Technical Service Bulletin

Cobra Motorcycle Mfg.

TSB0505: King airfilter upgrade with necessary airbox modifications

June 15, 2005

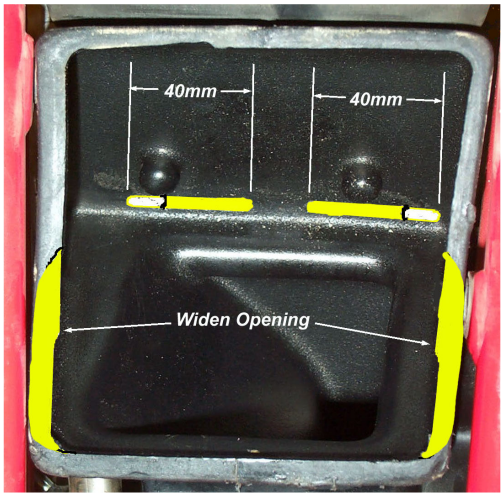
As the body of the new style air filter is more rigid, the opening in the top of the airbox must be opened a bit to allow easy in/out action. Also, the bottom slots must be opened towards the center as well. See picture below and remove material colored in yellow.

CAUTION:
Do not increase the slots entirely across into one single slot as the wire retainer will not have a surface to rest upon.

Increase the two slots in the bottom of the airbox inward for a new width of 40mm (1 5/8”) from an initial width of 15mm (5/8”)
